Product Stop Use, Inspection and Replace Notice – Immediate Action Required

Products Involved: All FallTech Full-Body Harnesses with Quick-Connect (bayonet style) Buckles

Duraform 350 06D

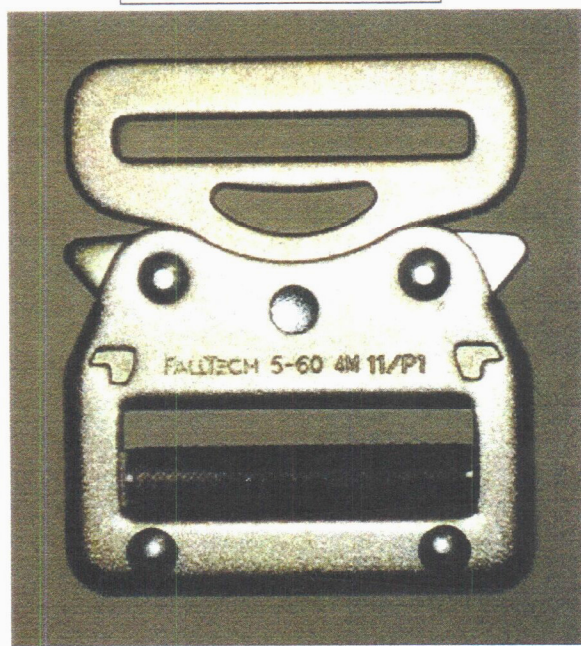
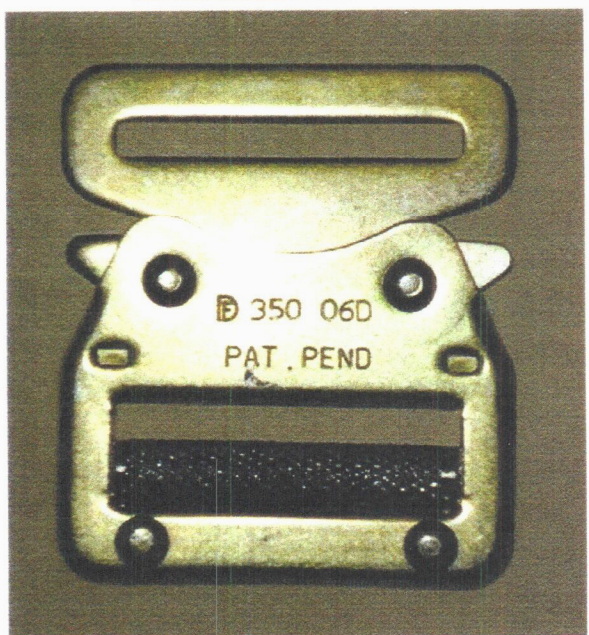
It has come to our attention that there is a defect with the Quick-Connect or Bayonet Style Buckles used in some of our Full Body Harnesses. On an unknown number of harnesses the male and female halves of this buckle set may have been improperly paired (i.e., the female half of the buckle may have been matched with the wrong male half of the buckle). This improper pairing can result in disengagement or unfastening of the buckle while the harness is in use, which can result in serious injury or death.

There are two buckle models that may exhibit this defect, which are as shown below as properly paired:

If you have any FallTech Full Body Harness with either of these buckles in use, or in your inventory that bears a manufacturing date of 10/12/2010 – 2/9/2012, it needs to be removed from service or stock immediately. The date of manufacture can be found in the center section of the first label on each Full Body Harness. Below is a listing of all Full Body Harness part numbers that may contain one or more of these buckles:

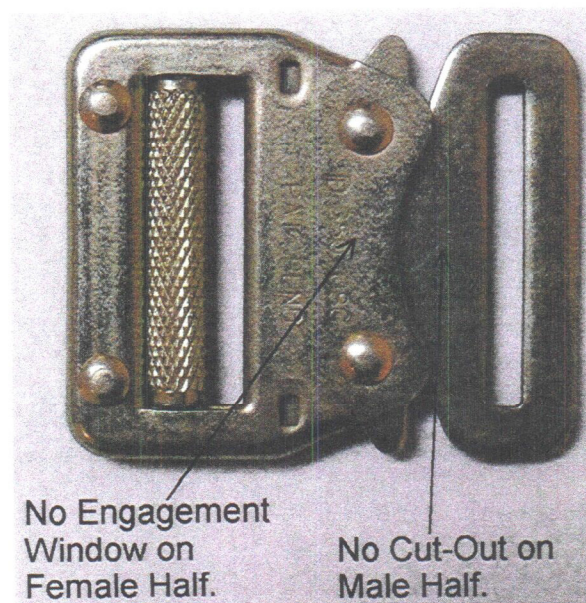
1. Locate each Quick-Connect Buckle on the harness, and ensure that each buckle is fastened together.
2. Examine both halves of the buckle. If the female half has an engagement window, and the male half has a crescent moon shaped cut out, then the buckle is properly paired, and can be returned to service if the harness is in otherwise serviceable condition. See the picture below:

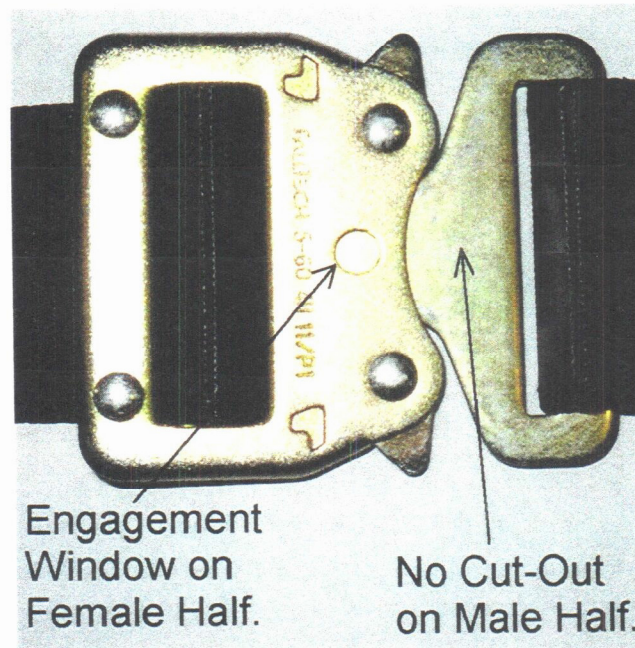
4. If the female half has an engagement window, but the male half does not have a cut-out, then the buckle is defective and must be removed from service and returned to FallTech for repair or replacement. See the picture below:

If the Quick-Connect Buckle(s) on your FallTech Full-Body Harness has an engagement window on the female half, and does not have a half moon shaped cut-out on the male half (as shown in #4 above), then it is defective and may not remain positively engaged while the harness is in use. Any FallTech Full-Body Harness having one or more buckles exhibiting this condition must be removed from service and returned to FallTech immediately. Failure to do so may result in serious injury or death.

If any of your harnesses has one or more defective Quick-Connect Buckles, make a note of the model number(s), date(s) of manufacture and quantity. Immediately contact FallTech's Customer Service Department at 800-719-4619 or 323-752-0066. We will immediately issue a return authorization and a call tag. The product(s) will be collected, repaired or replaced and returned to you at our expense.
